Revision of Manuscript Number: IEEE-TPWRS-01391-2021, version 1 February 19, 2022

Journal: IEEE Transactions on Power Systems

Author: Abhishek Halder, Kenneth F. Caluya, Pegah Ojaghi, Xinbo Geng

Response to decision:

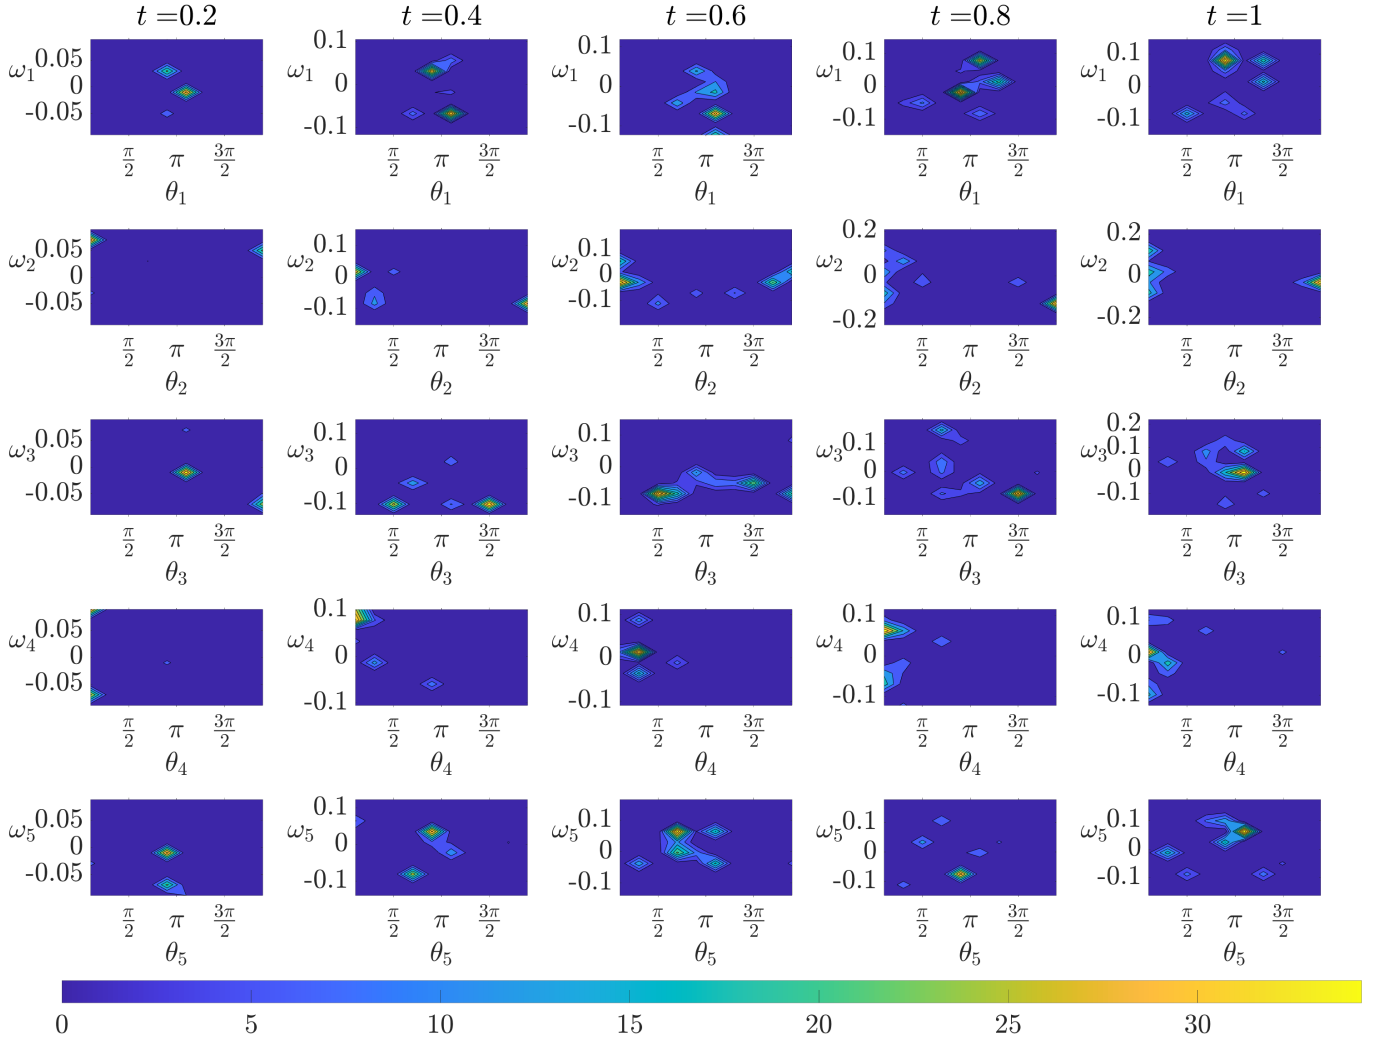
Figures 5 and 6 are unreadable.

Response: Thanks for this comment. In the previous version, the strict 10 page limit enforced small figure sizes. In the revised manuscript, Figures 5 and 6 are made larger. Also, the Fig. 6 in the revised manuscript shows the transient (θ_i, ω_i) bivariate marginals for all the five generators in Case II; the previous version showed the same only for the generator 4 (bus 6). We believe these changes have improved clarity.

Regarding the style of plots, we had considered plotting the bivariate marginals as planar contour plots (as in Fig. 1 in this rebuttal document) but decided against it because of the following two reasons.

First, in our opinion, this kind of plot is scientifically misleading as they hide the fact that these bivariate marginal PDFs are not really supported on the plane, or the subsets thereof, but instead have cylindrical supports. Our message that the proposed method explicitly accounts this manifold geometry in the computation, would be missed had we chosen to make the plots as per populist cognitive bias on behalf of the readers. That the planar plots evoke a sense of familiarity cannot be a scientific argument in favor of it.

Second, the planar contour marginal plots require additional mental efforts from the readers to correctly parse the statistical information conveyed. For instance, consider the fourth column, second row subplot in Fig. 1 in this rebuttal document. It is upon the reader to parse that the two high probability regions on the left and right of that subplot are actually referring to the same angular high probability region around $\theta_2 = 0$ rad, thanks to the periodic boundary condition on the angular variable. Our philosophy of technical communication is that the onus is on the authors, not on the readers, to clarify the scientific information as correctly as possible. And yes, we are aware that many papers in the power system literature make plots in the rectangular domain ignoring the manifold nature of the support, which in our experience, continue to add pain to the graduate students and beginning researchers trying to decipher the statistical meaning conveyed in those plots. We thus prefer to make plots that depict the variables as they are.
